REMARKS

Serial No.: 10/075,596

Replacement Sheet
U.S. Serial No. 12/075,596
7/28/03

FIG. 1

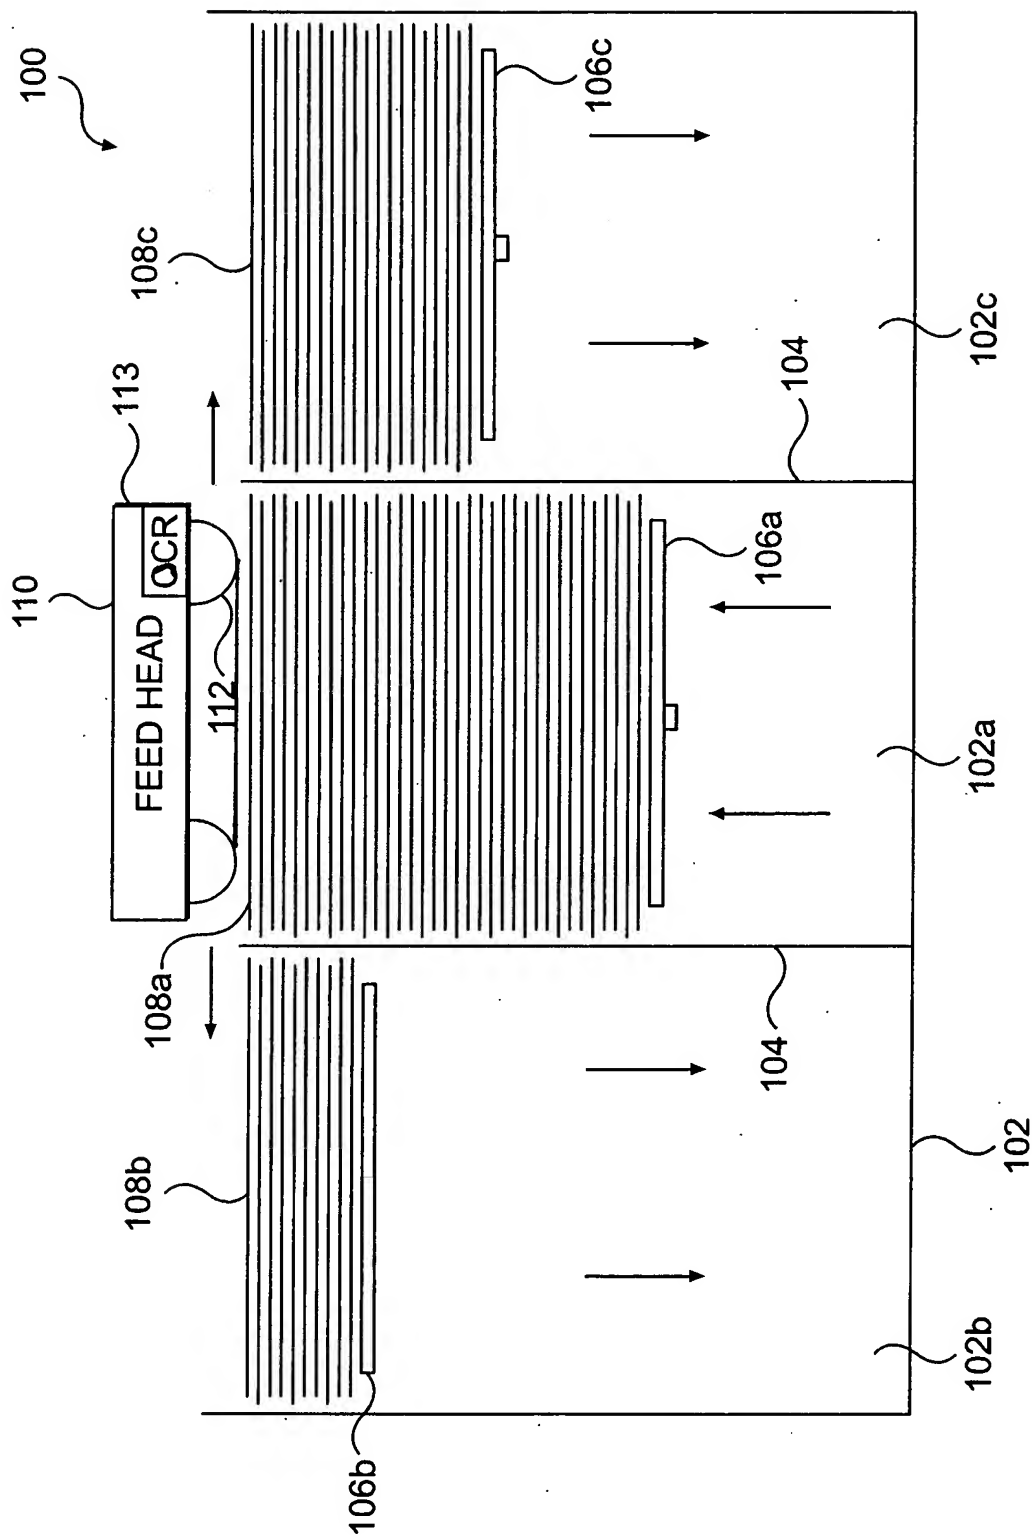
The drawings are amended to correct minor typographical and drawing errors. In figure 1, a belt 118 is shown. Also, "CCR" is changed to "OCR", as written throughout the specification. In Figures 2 and 3, "OCR" is placed in box 113. Additionally, in Figure 2, arrows are added at the end of lead lines for reference numerals 112 and 118. In Figure 4, a typographical error is corrected to "VACUUM" in box 112. Additionally, the addition of

FIG. 4

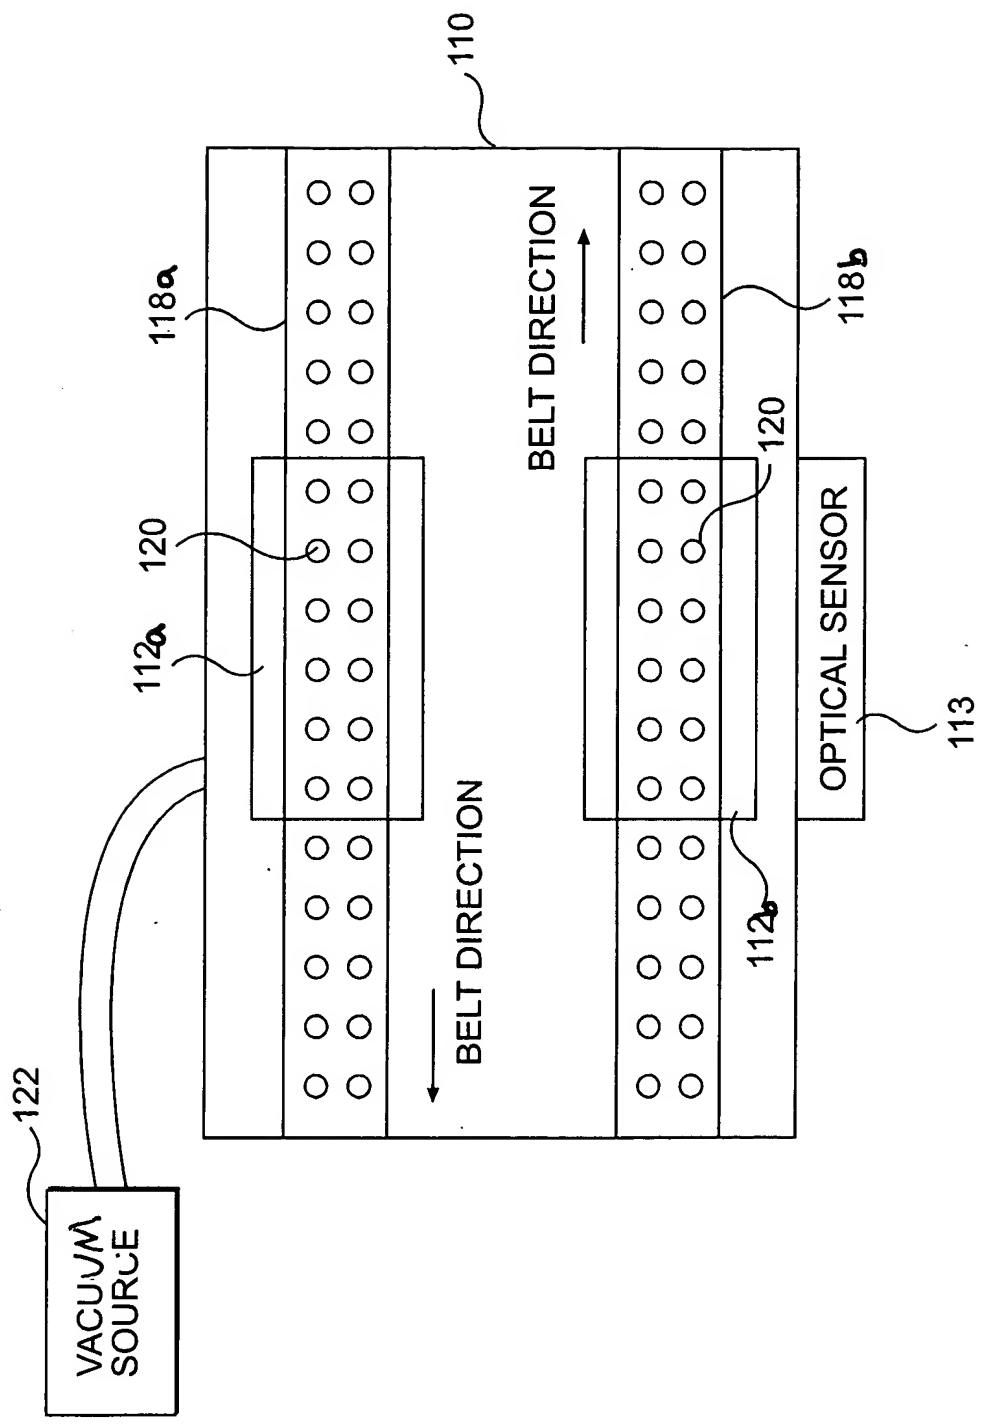
reference numerals 112a, 112b, 118a and 118b are added to Figure 4 to represent the different vacuum ports and the belts, as recommended by the Examiner.
